Model: AGL-P1	Date: 15-Jan-10	No.: RM078001d
---------------	-----------------	----------------

Subject: Firmware Release Note: Engine		Prepared by: H.kawamura	
From: PPBG Service Planning Dept.			
Classification:	<input type="checkbox"/> Troubleshooting	<input type="checkbox"/> Part information	<input type="checkbox"/> Action required
	<input type="checkbox"/> Mechanical	<input type="checkbox"/> Electrical	<input type="checkbox"/> Service manual revision
	<input type="checkbox"/> Paper path	<input type="checkbox"/> Transmit/receive	<input type="checkbox"/> Retrofit information
	<input type="checkbox"/> Product Safety	<input checked="" type="checkbox"/> Other (Firmware)	<input type="checkbox"/> Tier 2

Model: AG-P1/C1,AGL-P1/C1		Date: 05-Jan-11	No.: RG178129
Subject: Release of the Modified Fusing with "Hardened" Hot Roller		Prepared by: N.lida	
From: PPBG Service Planning Dept.			
Classification:	<input checked="" type="checkbox"/> Troubleshooting	<input checked="" type="checkbox"/> Part information	<input type="checkbox"/> Action required
	<input type="checkbox"/> Mechanical	<input type="checkbox"/> Electrical	<input type="checkbox"/> Service manual revision
	<input type="checkb

56.Fusing Unit 5 (D016/G178)

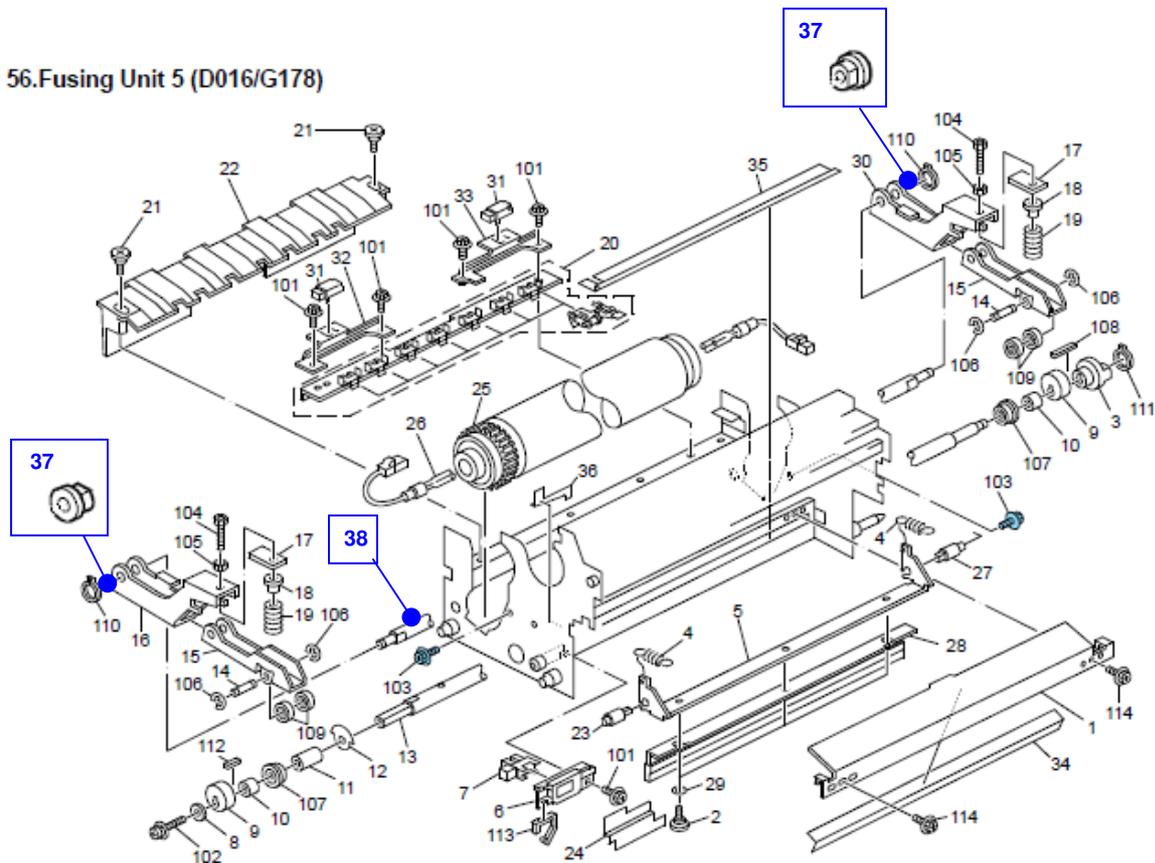
*1) Parts indexed 37 and 38 are service parts newly added for the modified fusing unit.

54.Fusing Unit 3 (D016/G178)

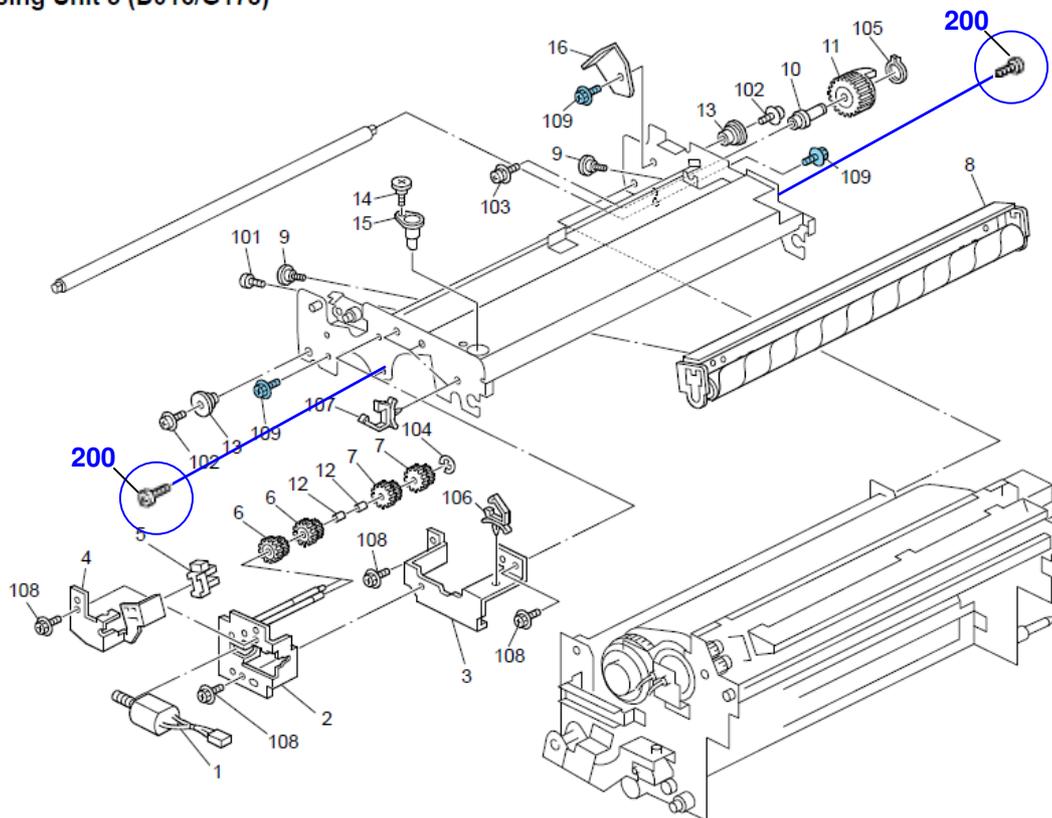
*2) The screws indexed 200 have been added to the locations shown in the diagram below in the modified fusing unit.

Index No.200
 P/N AA143803
 FLANGED HEXAGONAL HEAD BOLT:CASTER

How to distinguish the Standard and Modified fusing units

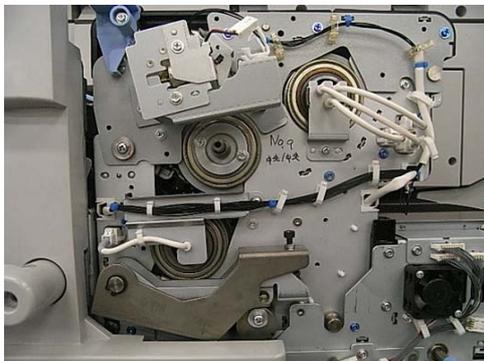
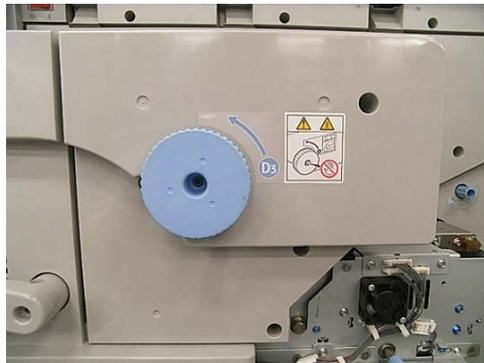
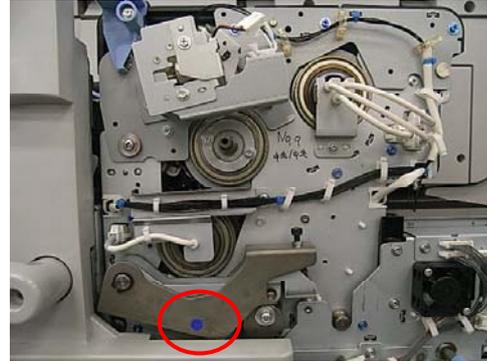
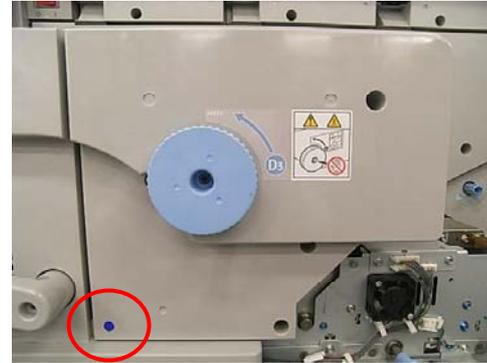
Although the units can be distinguished by the p/n indicated on the packaging boxes, it could be tricky after the units are installed in the mainframe. To enable distinction, the modified units are marked with blue stickers on the cover and the arm as shown in the photos above.

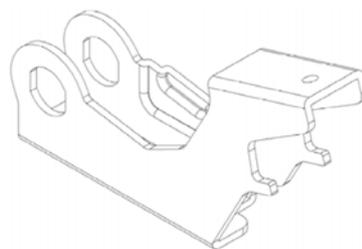
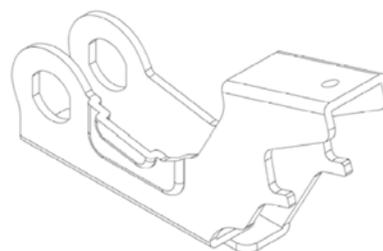
The arm for the standard unit is not durable enough to operate the modified unit and will cause the shaft to wear. The arm for the modified unit made of thicker plate is installed with a bushing to prevent wear and also has a different shape.

D0164468
COVER:FUSING UNIT:REAR

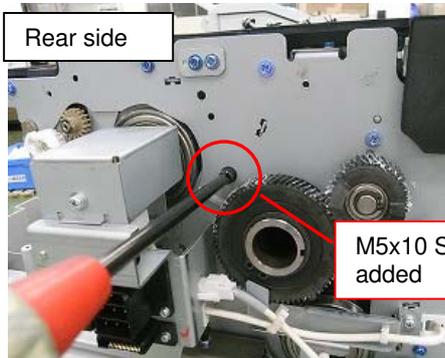
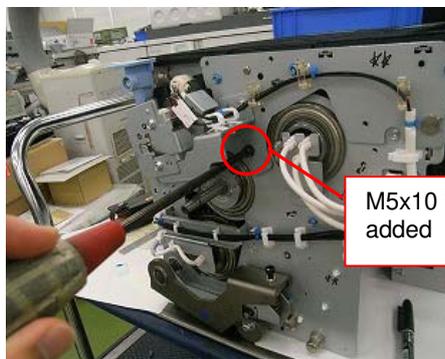
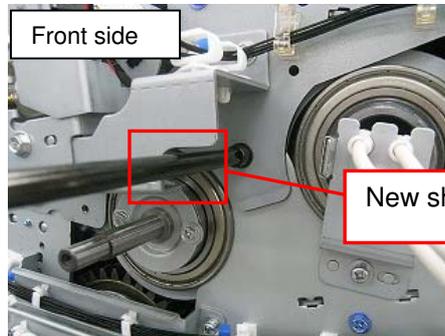
To avoid contact between the ribs on the cover and the pressure arm caused by the shape change of the pressure arm, the ribs on the cover have been partially removed.
